Modification Recommended Service Note

P5006A Keysight Streamline USB Vector Network Analyzer

Serial Numbers: From MY58100426 to MY58100451

Potential lifted front panel overlay

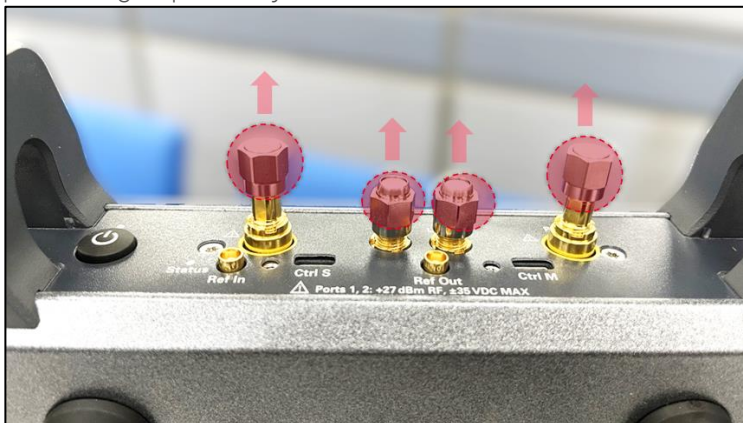
Keysight streamline series vector network analyzer (VNA) of serial number range identified in service note cover page might potentially exhibit the following lifted front panel overlay symptom.

Apart from cosmetic imperfections, the lifted front overlay could have led to non-fully attached *Ctrl S* micro-HDMI cable connector in multi-VNAs setup configuration.

-> Apply this service note only if end users' VNA is exhibiting the following symptom.

Procedure to replace the front panel overlay.

1. Remove the front handles. Detach the 50-ohm termination (LO-In, LO-Out, Port 1 & Port 2) or protecting caps if they are attached to the VNA.

2. Pry open the existing front panel overlay and remove it from front panel.
3. Clean the metal surface thoroughly and ensure it is free of adhesive residue.
4. Affix the new self-adhesive front panel overlay onto the metal surface.
5. Reinstall (reuse) the 50-ohm terminations or protecting caps accordingly.

6. Reinstall (reuse) the front handles.
